Appeal of HPC Determination 1239 Rossmoyne Avenue

Appeal Case No. PAPP-003276-2024
City Council - August 13, 2024

Case No.: Design Review Case No. PDR-003119-2024

1. The second-floor balcony shall not be enclosed.

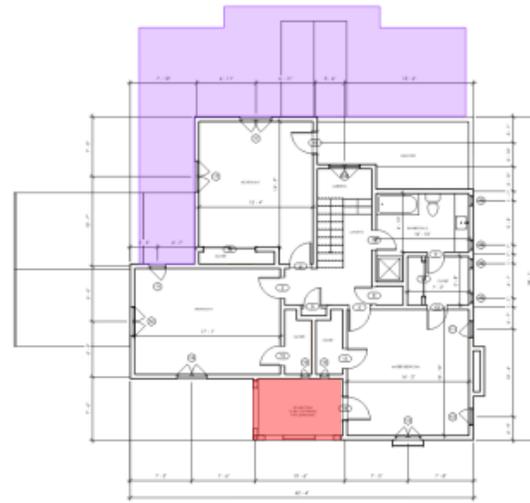
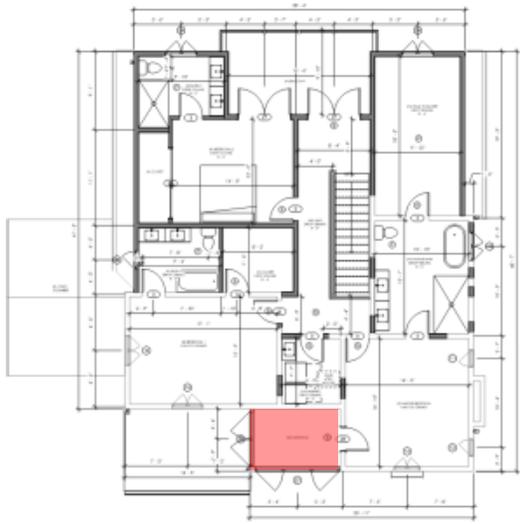
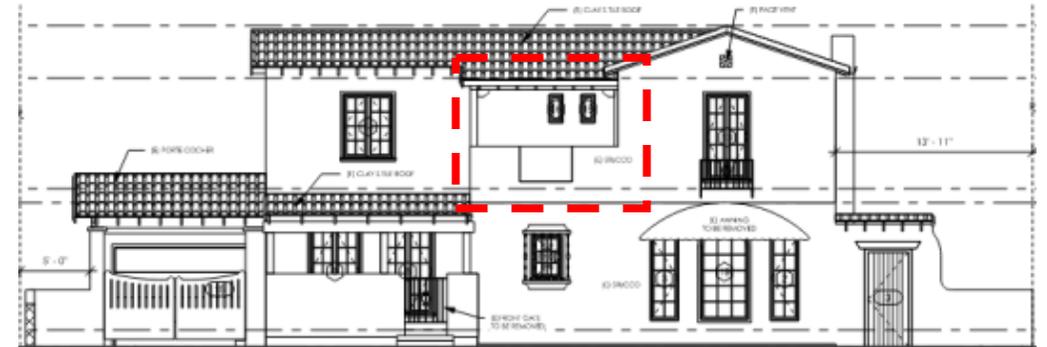
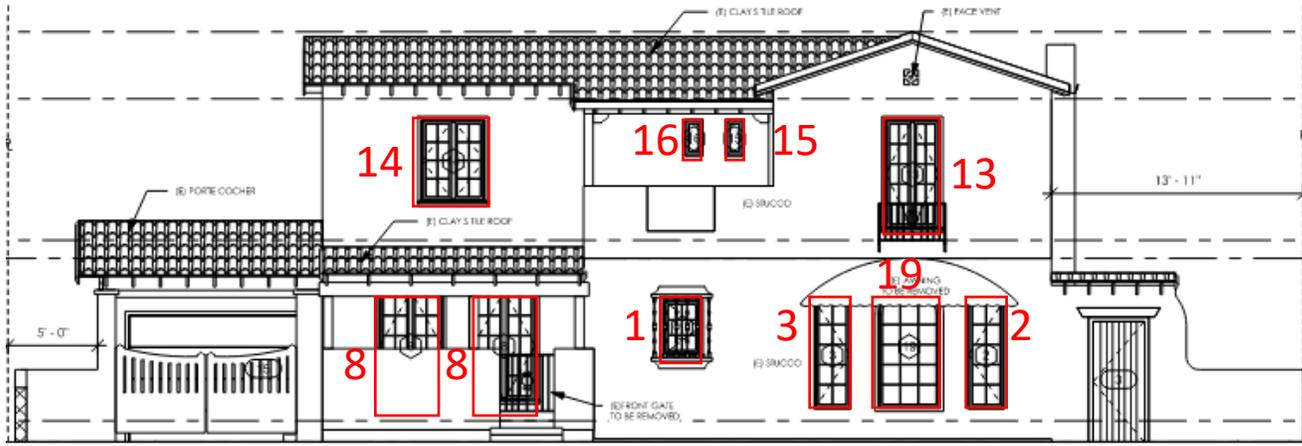
1. The second-floor balcony shall not be enclosed.
